HITACHI MICROCOMPUTER TECHNICAL UPDATE

DATE	25 January 2001	No.	TN-SH7-272A/E
THEME	Bug of a serial data reception of the multiprocessor communication function at SCI		
CLASSIFICATION	<input type="checkbox"/> Spec change <input checked="" type="checkbox"/> Limitation on Use <input type="checkbox"/> Supplement of Documents		
PRODUCT NAME	HD6417750 ,HD6417750S ,HD6417751	Lot	Lot #All
REFERENCE DOCUMENTS	SH7750 series Hardware Manual	Rev.	Effective Date
	SH7751 Hardware Manual		Eternity

Fig.1 A sample of a flowchart of a multiprocessor serial data reception

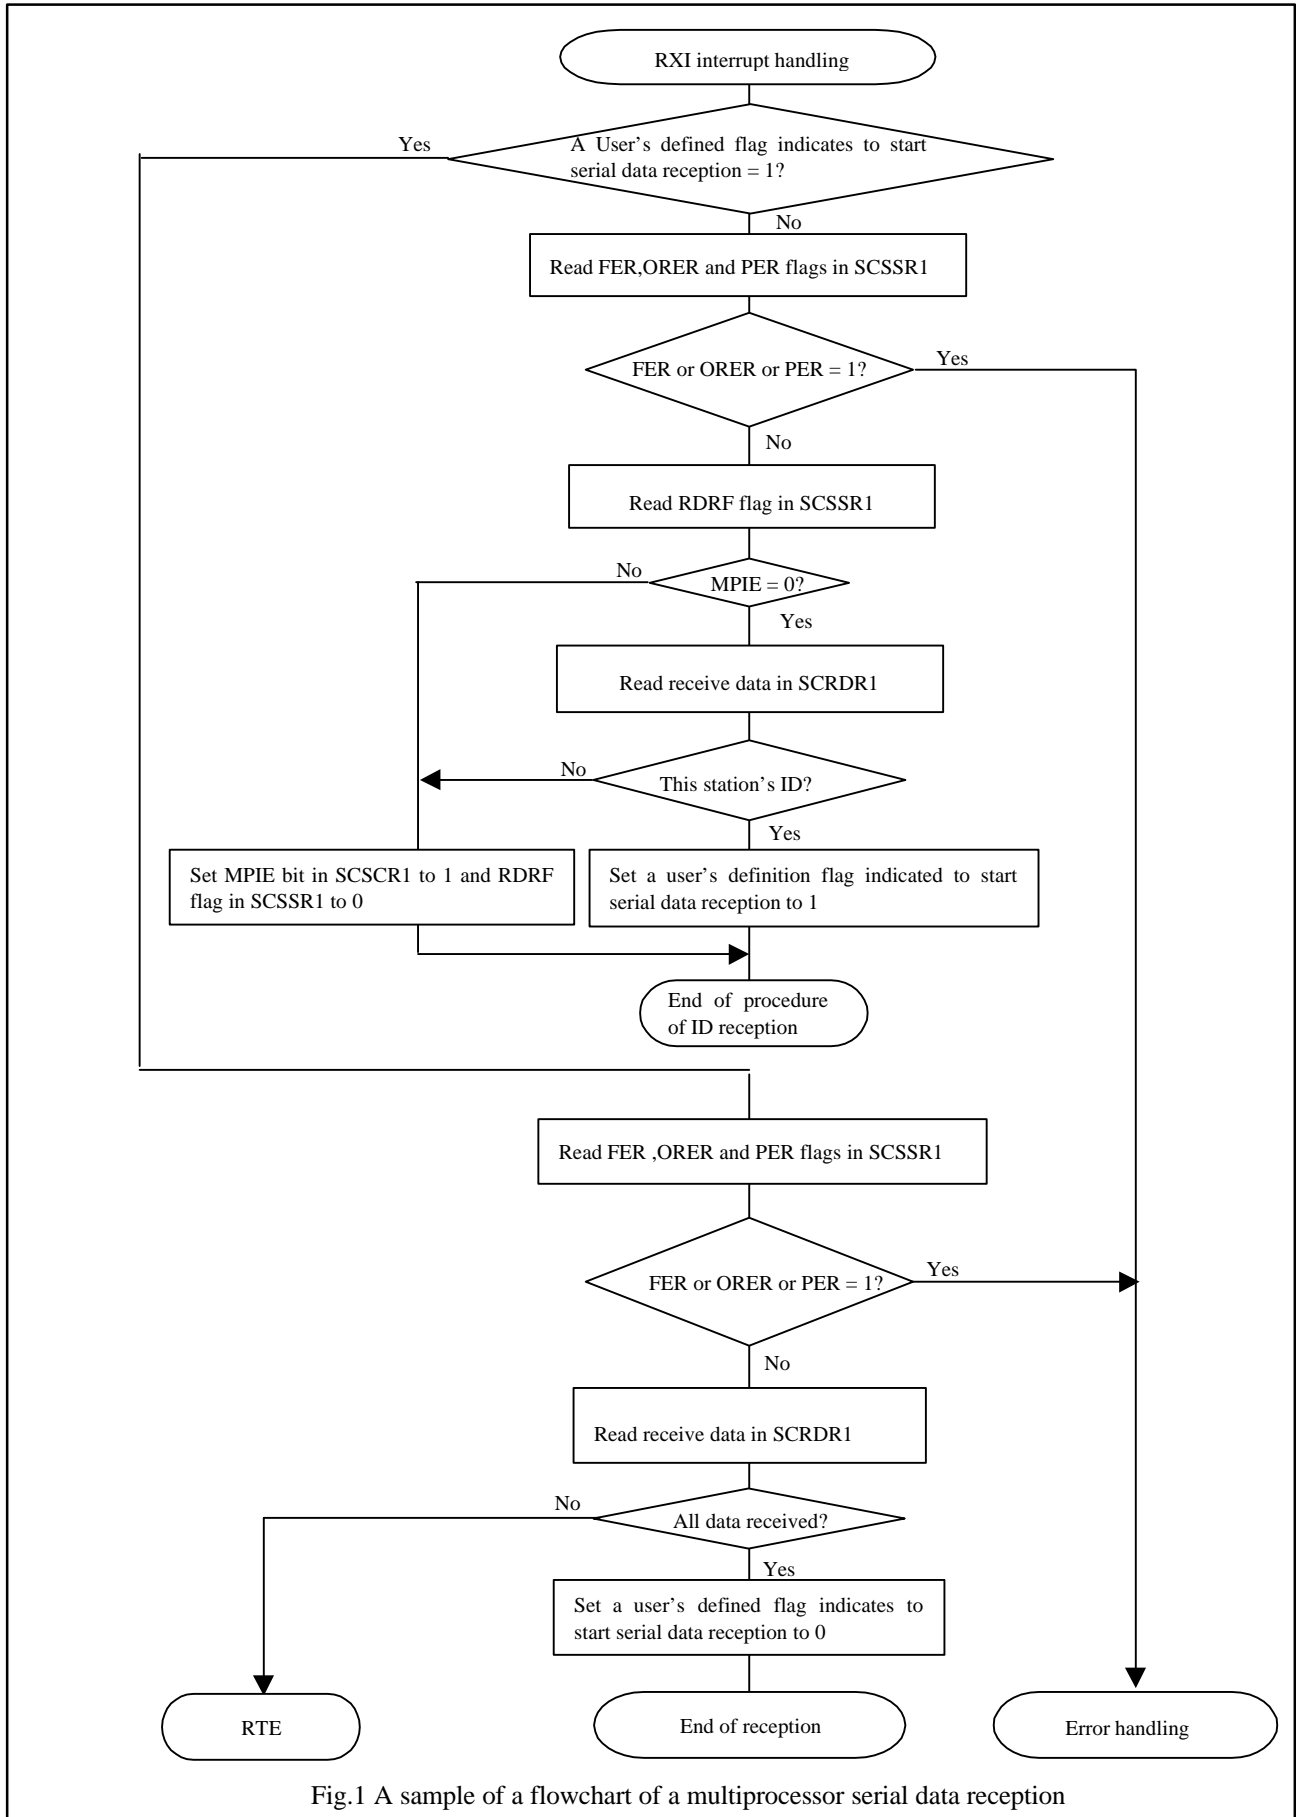
- (1) SCSSR1.RDRF flag is set to 1 in the multiprocessor serial data reception after received a frame of data for another station even if SCSCR1.MPIE bit equals 1(the multiprocessor interrupt enabled).
- (2) The value of SCSSR1.MPB bit is not correct.
- (3) The flags, FER and ORER, can be set to 1 even if SCSCR1.MPIE bit equals 1.

Don't use SCSSR1.MPB bit for the processing of software.

In the processing of software to distinguish a receive data between this station's ID (MPB=1) and a valid data (MPB=0), please create a user's defined flag on a memory which indicates information about starting a serial data reception.

A sample of a flowchart of a multiprocessor serial data reception is shown in the following.
